Request for Further Information under Section 92(1) of the Resource Management Act 1991 - Application for Resource Consent - Ngāi Tahu Seafood Resources

Thank you for your application on behalf of Ngāi Tahu Seafood Resources (NTS) to develop approximately 2,500 hectares of the coastal marine area offshore from the northern coast of Rakiura/Stewart Island for fin fish farming.

Figure 6. Time-averaged current speeds measured from the three deployed ADCPs.

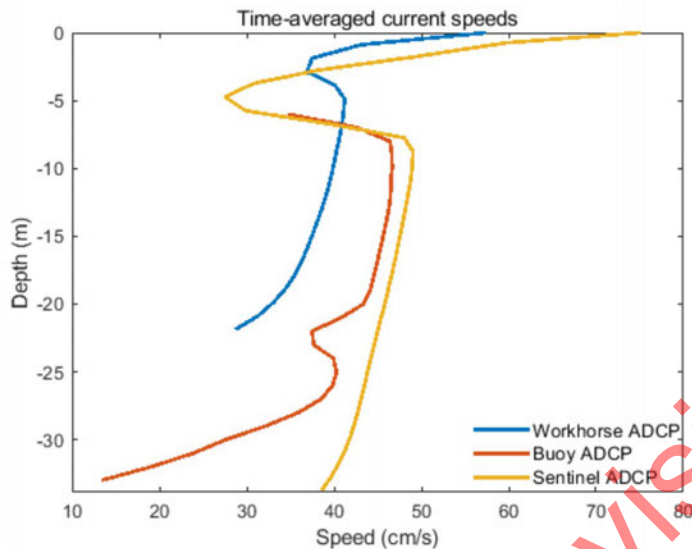
The current velocities shown in Table 2 do not appear to match the velocity profile shown in Figure 6. Particularly near-seabed current velocities in Table 2 are considerably higher than those indicated in Figure 6 and mid-depth velocities for the Workhorse and Buoy ADCPs also appear higher in Table 2 than in Figure 6.

1. Please explain the differences between current speeds shown in Table 2 and Figure 6.
2. Based on the current profiles shown, it is counter-intuitive that the mean depth-averaged current speed is smaller than the current speed at all three measured locations. Please describe how mean depth-averaged current speed was calculated and which section(s) of the water column experience the lowest current speeds.
